Access Compliance Report

(Curb Ramps)

Intersection ID: 23880	Main Street: CHINA GROVE CHURCH RD	Cross Street: STERLING LN	Location: SW
ADA ID: DFFC26CCB237	Ramp Type: PerpDiag	Initial Pass/Fail: Fail	Overall Compliance: No
Severity Score: 46.25			
Codes/Mitigation Info/Possible Solution		Field Measurements/Component Compliance

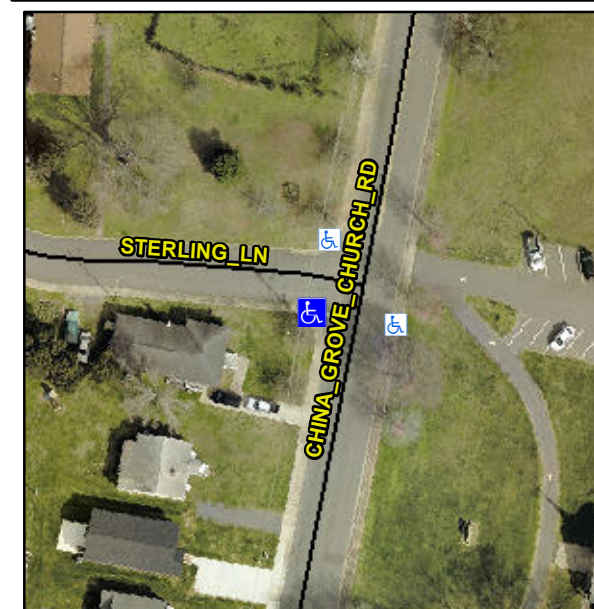
R304.5.1, R304.2.2, R304.5.3

Compliance	Description	Data	Compliance	Description	Data
N/A	Ramp Length (in)	48.0	No	Ramp Slope (%)	14.9
No	Ramp Width (in)	37.0	No	Ramp XSlope (%)	5.1
N/A	Flare Type LT	N/A	N/A	Flare Type RT	N/A
N/A	Flare Slope LT (%)	N/A	N/A	Flare Slope RT (%)	N/A
N/A	Flare Traversable LT?	N/A	N/A	Flare Traversable RT?	N/A
N/A	Landing Length (in)	N/A	N/A	DWS Provided?	N/A
N/A	Landing Width (in)	N/A	N/A	DWS Contrast?	N/A
N/A	Landing Slope (%)	N/A	N/A	DWS Length (in)	N/A
N/A	Landing X Slope (%)	N/A	N/A	DWS Full Width?	N/A
N/A	Landing Curb? (Y/N)	N/A	N/A	DWS Offset (in)	N/A
N/A	Shared Landing?	N/A			
N/A	Gutter Ponding?	N/A	N/A	Gutter Slope (%)	N/A
N/A	Gutter Lip Ht (in)	N/A	N/A	Gutter X Slope (%)	N/A
N/A	Painted X Walk1?	No	N/A	Painted X Walk2?	No
	X Walk 1 Direction	To SE		X Walk 2 Direction	To NE
N/A	X Walk 1 Width (in)	N/A	N/A	X Walk 2 Width (in)	N/A
	X Walk 1 Slope (%)	2.6		X Walk 2 Slope (%)	2.0
	X Walk 1 X Slope (%)	0.6		X Walk 2 X Slope (%)	6.6

Remove & Replace Curb Ramp With Two New Directional Ramps or Equivalent.
